Agenda
Village of Arlington Heights
Design Commission
Community Room, 3rd Floor

Arlington Heights Village Hall
33 S. Arlington Heights Road
Arlington Heights, IL 60005
August 25, 2015
6:30 PM

- A. DC#15-095 - 922 N. Beverly Ln. - SF/Teardown
- B. DC#15-101 - 1138 N. Mitchell Ave. - SF/Teardown
- C. DC#15-098 - Olive-Mary Stitt School - 303 E. Olive St.
- D. DC#15-099 - Ivy Hill School - 2211 N. Burke Dr.
- E. DC#15-096 - The Moorings - 811 E. Central Rd. - Institutional

4 SOUTHWEST ELEVATION -- GYMNASIUM
SCALE: 1/8" = 1'-0"

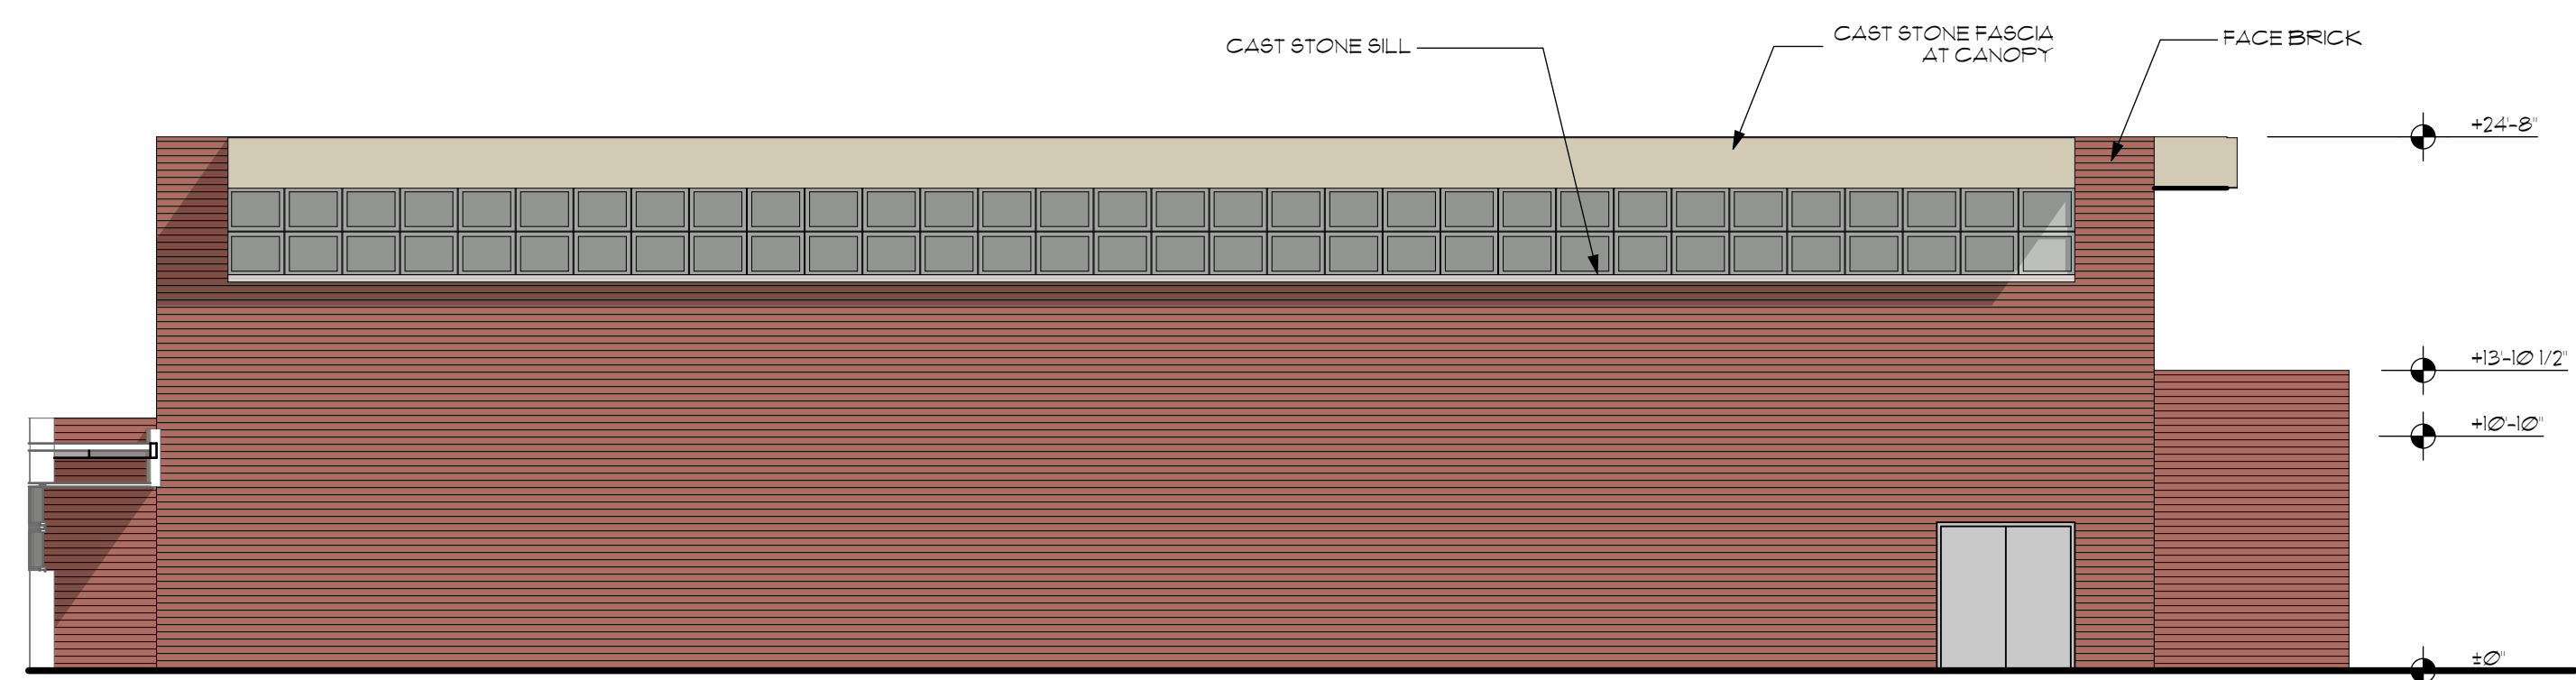
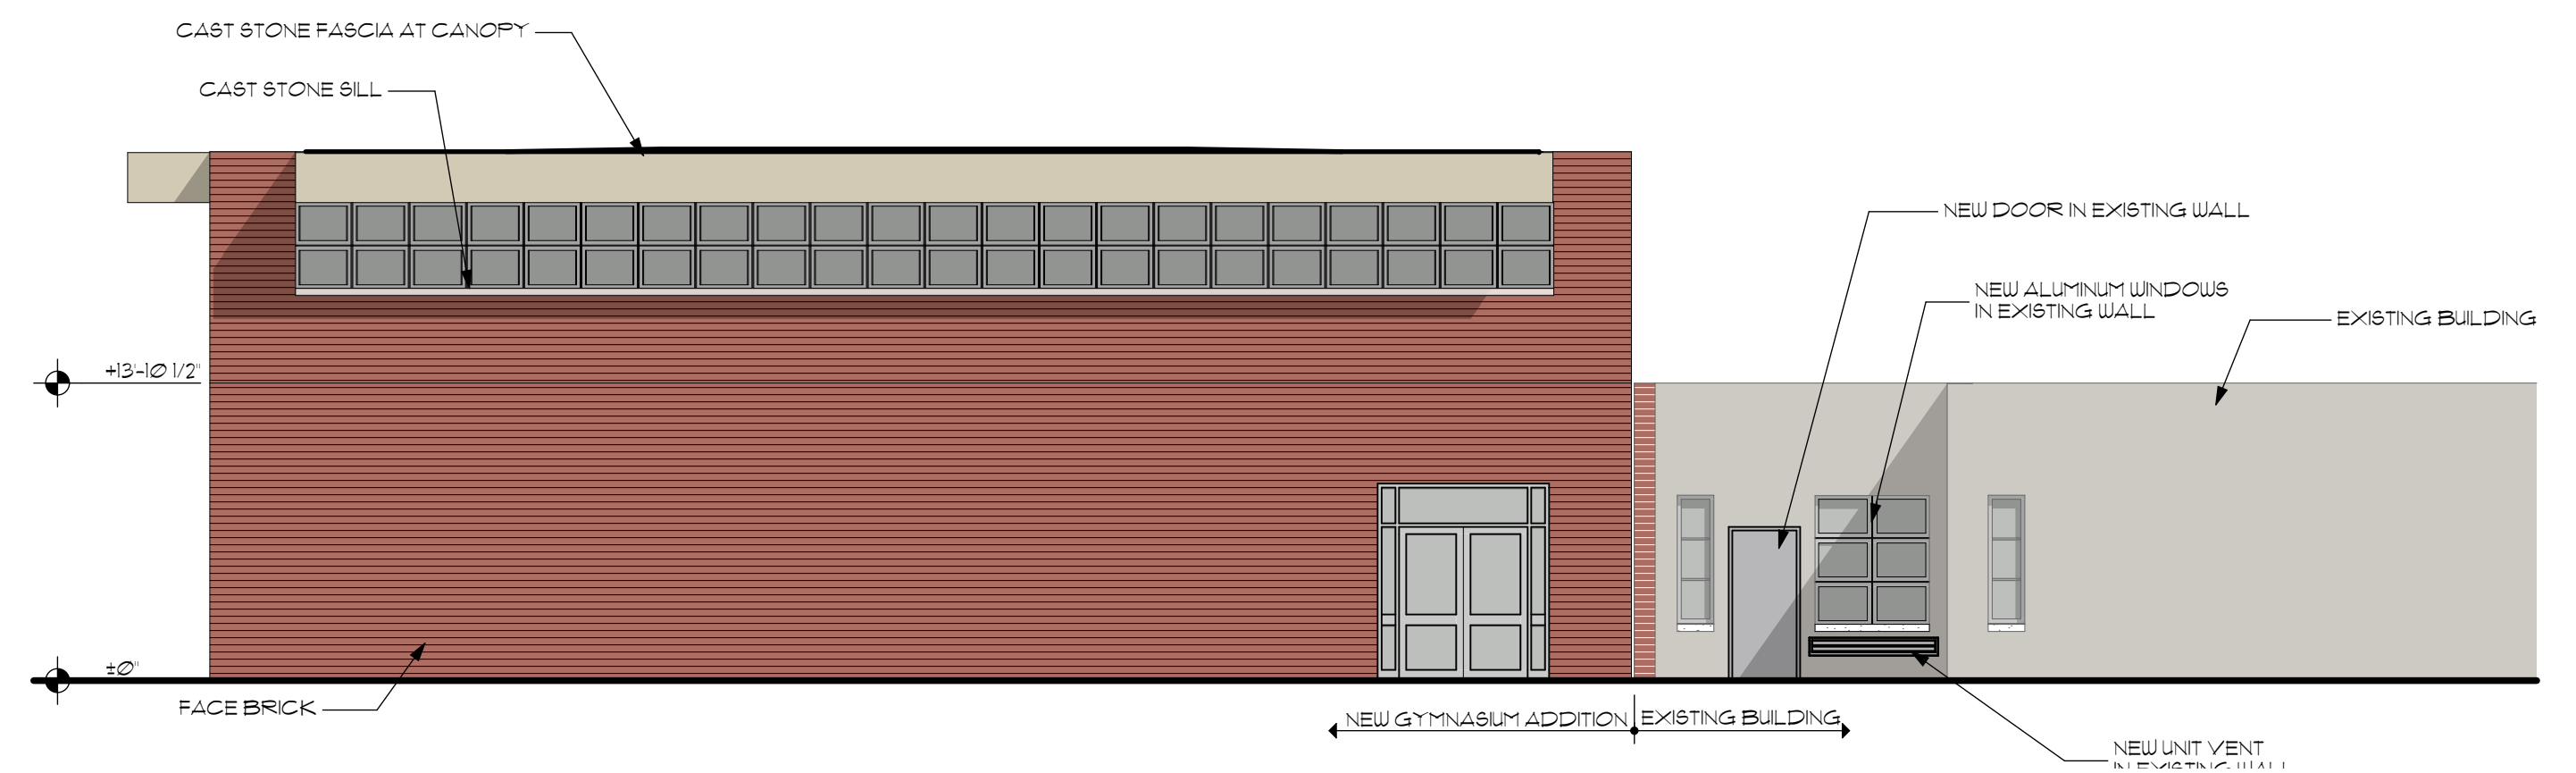
The proposed clerestory gymnasium windows is a nice detail that matches the existing building window patterns which adds interest to the design and helps to integrate the addition with the existing building. However, the proposed gymnasium does have large solid brick walls facing the nearby adjacent single family homes to the south. Therefore, it is recommended that additional landscaping be added on the south and southwest elevations of the proposed gymnasium, including evergreen trees, to help soften the building mass adjacent to the residential district.

1. Provide a dark bronze metal coping at the top of the brick walls to match the existing building.
2. Provide additional landscaping, including evergreen trees, along the south and southwest gymnasium elevations to soften the building mass.
